Item 5.**Modification Application: 58-78 and 82-106 Oxford Street, Darlinghurst - D/2020/1071/C****File No.:** D/2020/1071/C**Summary****Date of Submission:** 10 February 2023, further information was supplied 26 May 2023 and 2 August 2023**Applicant:** Daniel Litchfield**Architect/Designer:** FJMT Studio**Owner:** The Council of the City of Sydney**Planning Consultant:** Jethro Yuen - Ethos Urban**Heritage Consultant:** Paul Davies Pty Ltd**Cost of Works:** \$44,085,318**Zoning:** The site is located in the E1 Local Centre zone.

Proposal Summary: The application seeks consent for a section 4.55(2) modification to the approved mixed-use development currently under construction at 82-106 Oxford Street, Darlinghurst.

Figure 41: Comparison between the approved level 2 floor plan and the proposed level 2 floor plan showing removal of eastern lightwell ribs, new internal openings, window modifications and new lift core location

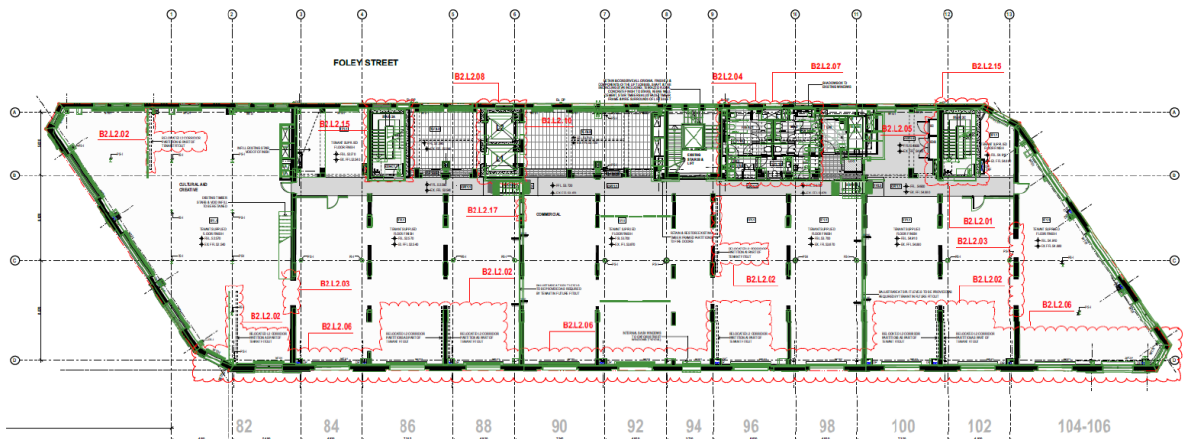
B2.L2.03	New openings with a maximum width of 2170mm are proposed to the masonry walls along gridline 3 and 13.	The proposed change is supported as it is a minor change to enhance circulation within the new tenancy. The changes will not adversely impact legibility of the existing original intertenancy walls within the space. The heritage impacts are therefore acceptable.
B2.L2.04	The bathroom layout is proposed to be revised.	The change to the bathroom is a reconfiguration of previously approved new fabric. The change is supported, as there are no planning or heritage issues arising as a result of the modification.

Drawing references and condition amendments	Proposed modifications and applicant's submission	Assessment
B2.L2.05	Electrical services are proposed to be relocated.	The repositioning of the electrical services is supported as it is a minor change to non-original fabric and will have no heritage or planning implications.
B2.L2.06	The original floorboard perimeter that is exposed along Oxford Street is proposed to be covered by a new structural plywood floor strengthening diaphragm.	The proposed modification for a new structural plywood floor strengthening diaphragm is supported. The method is considered acceptable by Council's Heritage Specialist as it retains the original floorboards in situ and avoids damage to them caused by lifting.
B2.L2.07	It is proposed to modify window VXHM.B202.02 for mechanical intake. The existing timber window frames and sashes are proposed to be retained and the glazing replaced with metal louvres.	The modification to window VXHM.B202.02 is supported as it allows for mechanical ventilation of the building using existing window openings and is reversible. The modification has a minor heritage impact.

B2.L2.08	Windows WXH.B202.30 backs onto the new lift core. It is proposed to replace the glazing on window WXH.B202.30 with colour backed (black) strengthened glass to prevent glass from shattering when the cavity between the existing façade and new lift core is subject to high heat.	The proposed change to window WXH.B202.30 is acceptable as it is minor work required for safety purposes, which will not adversely affect the legibility of the retained timber sash frame, the existing opening proportion, or of the arched brick header. The modification will have no unreasonable heritage impacts and is easily reversible.
B2.L2.09	It is proposed to remove the section of plain ceiling above the non-original corridor to Level 2 and install a new decorative panelled plaster ceiling to match the existing decorative panelled plaster	This modification to install a new decorative panelled plaster ceiling is supported as it is a positive heritage outcome that will unify the heritage ceilings within each space.

Drawing references and condition amendments	Proposed modifications and applicant's submission	Assessment
	ceiling in the main space of the level.	
B2.L2.10	It is proposed to remove the roof and ceiling between gridlines 11 and 13 to allow for construction of new services, the level 3 structure, and to meet fire-rating requirements. It is also proposed to reconstruct a new plaster ceiling using the same patterns and layout as the existing ceiling.	The replacement of the plaster ceiling is supported as it facilitates removal of fabric of little relative significance, in order to allow for construction of new services and compliance with fire rating requirements. Replacement with like-for-like will allow for retained legibility of this part of the building. This modification will have no adverse heritage impacts.
B2.L2.11	The existing introduced patterned ceiling between gridlines 2 and 3 is proposed to be replaced with a new patterned ceiling which matches the pattern of the adjacent 1912 ceiling panels.	The replacement of this portion of ceiling is supported as it will enable enhanced legibility of original building detailing within this section of the building and is therefore considered a positive heritage outcome.

Drawing references and condition amendments	Proposed modifications and applicant's submission	Assessment
	facilitate access to spaces above the ceiling during construction.	ceiling linings which will enable future legibility of the original corridor alignment). The work will result in neutral heritage impacts.
B2.L2.14	The proposed ceiling fittings have been included in the amended Architectural Drawings. The finished ceiling levels are also proposed to be revised to suit the reconfigured spaces and new survey information.	The reconfiguration of previously approved modifications to the ceilings to accommodate required new services is supported. The proposed changes are necessary, minor and on the whole will not adversely impact the legibility of the reinstated, original moulded plaster ceilings.
B2.L2.15	Stair 2A and 2C which were previously proposed for full demolition, are proposed to be relocated off the existing party wall near gridlines 4 and 12, respectively. A new core is proposed comprised of a retained existing party wall on one side and new concrete walls to the other three sides.	The proposed relocation of stair 2A and 2C is supported as it results in reduced demolition of original fabric, less stabilising works and is a positive heritage outcome.

B2.L2.16	The new lift core is proposed to be relocated east of the existing party wall on gridline 6 which was previously proposed for full demolition. New openings for access to the lift are proposed	The lift core relocation is supported as it will reduce vertical cuts through the existing cross bracing walls and will result in the retention of more original heritage fabric.
B2.L2.17	A new 970mm-wide opening is proposed in the existing masonry wall at gridline 6.	The proposed 970mm-wide opening is supported as it is a minor change to enhance circulation within the new tenancy. The changes will not adversely impact legibility of the existing original intertenancy walls within the space. The heritage impacts are therefore acceptable.

Figure 42: Comparison between the approved level 3 floor plan and the proposed level 3 floor plan showing change to external slab, revised bathroom layout and new lift core location

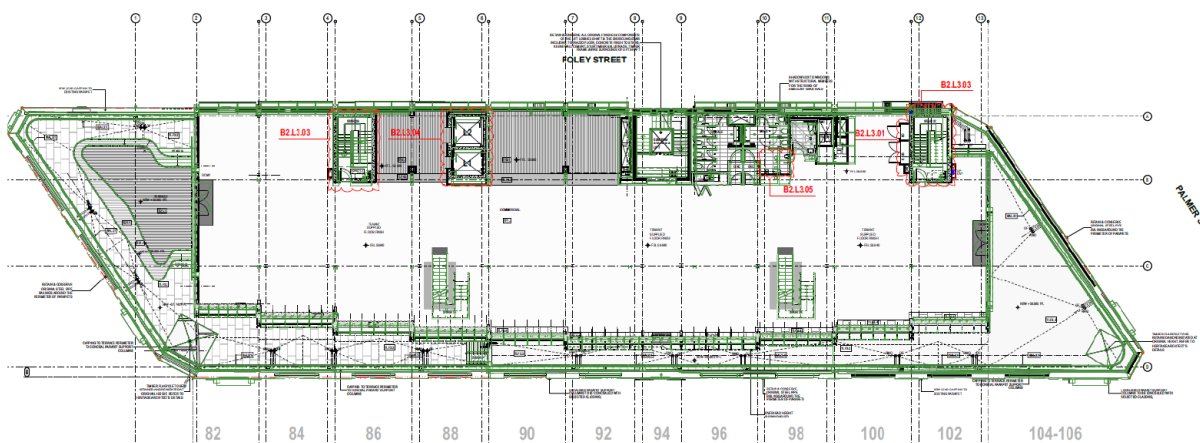
Drawing references and condition amendments	Proposed modifications and applicant's submission	Assessment
Level 3		
B2.L3.01	The electrical cupboards are proposed to be relocated.	The repositioning of the electrical services is supported as it is a minor change to non-original fabric and will have no heritage or planning implications.
B2.L3.02	The external terrace slab is proposed to be changed to Bondek material.	The proposed change to include Bondek material for the external terrace is supported as it is replacement of a non-original element and will not impact the visual presentation of the approved addition.
B2.L3.03	The dimensions and location of Stairs 2A and 2C are proposed to be adjusted in accordance with the proposed changes to Stairs 2A and 2C on the levels below.	The proposed change to the stair dimensions is a result of the relocation of stair 2A and 2C on the levels below and is supported. As discussed above, the proposed relocation of stair 2A and 2C is supported as it results in reduced demolition of original fabric, less stabilising works and is a positive heritage outcome.

B2.L3.04	The dimensions and location new lift core is proposed to be adjusted in accordance with the proposed changes to the lift core on the levels below.	The lift core relocation is supported as it will reduce vertical cuts through the existing cross bracing walls and will result in the retention of more original heritage fabric.
B2.L3.05	The layout of the bathrooms is proposed to be revised.	The change to the bathroom is a reconfiguration of previously approved new fabric. The change is supported, as there are no planning or heritage issues arising as a result of the modification.
B2.L3.06	The demolition extents required for Stairs 2A and 2C and the new lift core are revised.	The proposed amendment to the extent of demolition to facilitate the relocation of Stairs 2A and 2C and the new lift core are supported. As discussed above, the proposed

Drawing references and condition amendments	Proposed modifications and applicant's submission	Assessment
		relocation of Stair 2A and 2C and the new lift core is supported as it results in reduced demolition of original fabric, less stabilising works and is a positive heritage outcome.
Level 4		
B2.L4.01	The dimensions and location of the new lift core are proposed to be adjusted in accordance with the proposed changes to the lift core on the levels below.	The lift core relocation is supported as it will reduce vertical cuts through the existing cross bracing walls and will result in the retention of more original heritage fabric.
Roof level		
B2.RF.01	The form and set out of the roof are proposed to be adjusted in accordance with the shift in the lift core location on the levels below.	The minor change to the form and set out of this portion of roof is supported as it is a proposed change to a new material (non-original fabric and is required to facilitate the shift in the lift core location. The proposed change remains compliant with the Sydney LEP 2012 alternative height control of 25 metres.

Figure 46: Extract of approved lower ground level. End of journey facilities are shown in orange and existing approved storage/ plant areas are shown in grey

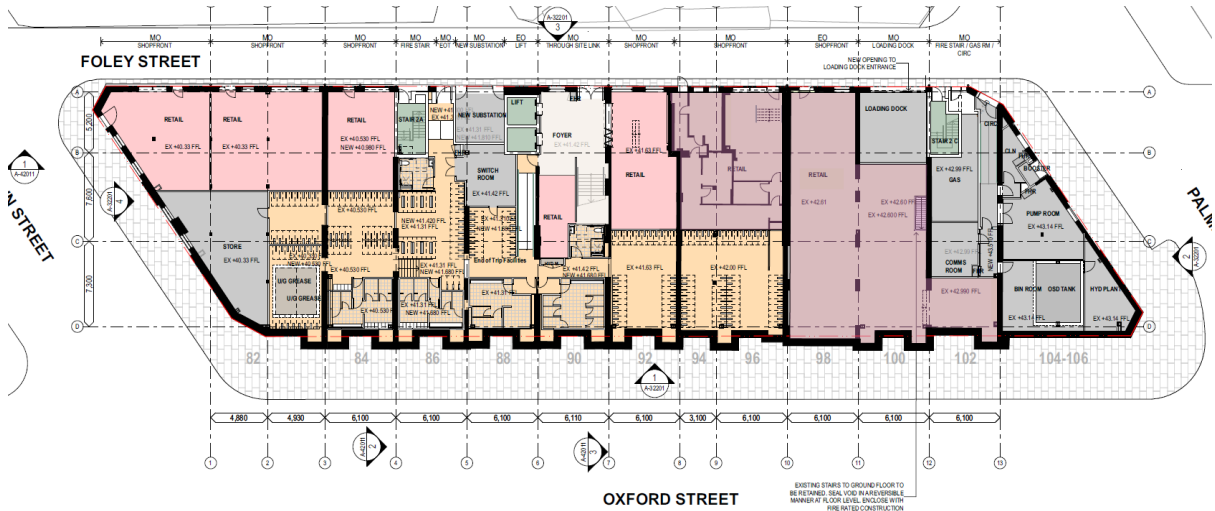
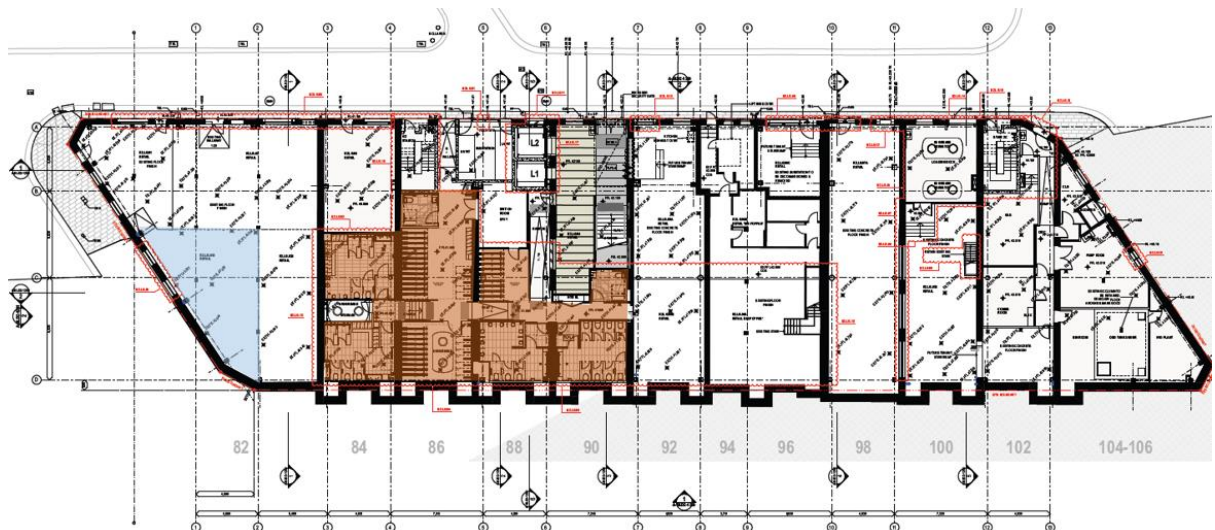
32. A redistribution of floor space and an increase of overall gross floor area is proposed as part of this modification which includes:
 - (a) Reduction of end of journey floor area by 168.42 square metres from 461.9 square metres (0.28:1) to 293.48 square metres (0.18:1), with some efficiencies achieved through double-stacked bicycle parking. The 168.42 square metre area previously approved as end of journey is proposed to become retail floor space (refer to Figure 46 and 47 below).

- (b) Amending the overall gross floor area of each level due to design development and inclusion of a previously approved storage area as retail floor space (refer to Figure 46 and 47 below). This results in an overall increase of 47.8 square metres of gross floor area. The resultant overall gross floor area excluding end of journey is 6,867.52 square metres (4.12:1) and 7,161 square metres (4.29:1) including end of journey floor space.

- 33. Figure 46 below is an extract of the originally approved lower ground level showing the approved end of journey floor space in orange and the approved storage area in grey to the left of the end of journey facilities.

- 34. Figure 47 below is an extract of the proposed lower ground level. The reduced end of journey area is highlighted in orange and the storage area, proposed to become retail space, is highlighted in blue.

36. The redistribution of floor space within the building is supported for the following reasons:
- The change to gross floor area does not result in any change to the bulk and scale of the development;
 - The development continues to maintain adequate on-site end of journey facilities and bicycle parking for the development within the reduced end of journey area;
 - The overall FSR of the development remains compliant with the alternative maximum FSR development standard 4.5:1 under clause 6.60D of the Sydney LEP 2012; and
 - The modification continues to maintain an additional 10% of the overall floor space area for cultural and creative purposes.

Figure 48: Extract of approved lower ground level showing the location of the approved loading dock circled in red

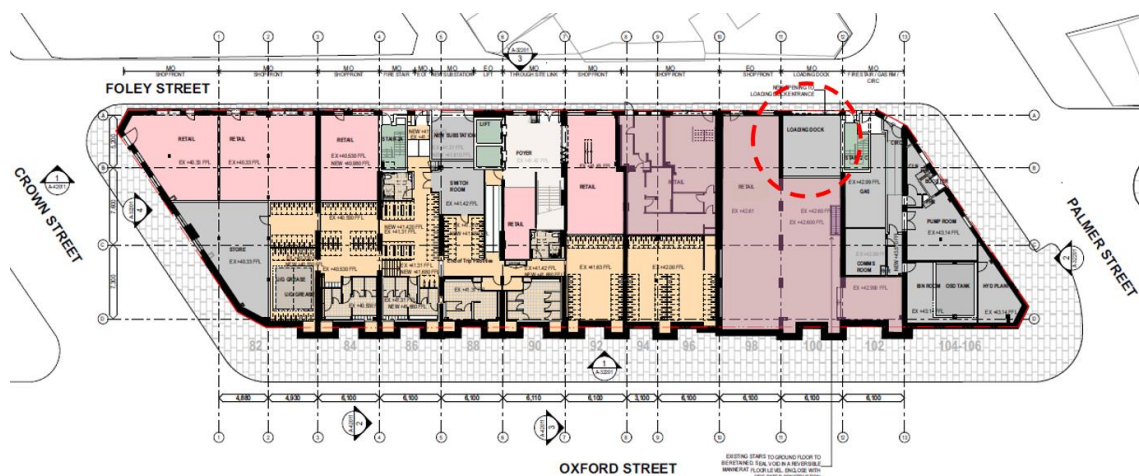
44. A loading dock for the whole development was originally approved on the southern end of the lower ground level of Group 2 along Foley Street (refer to Figure 48).
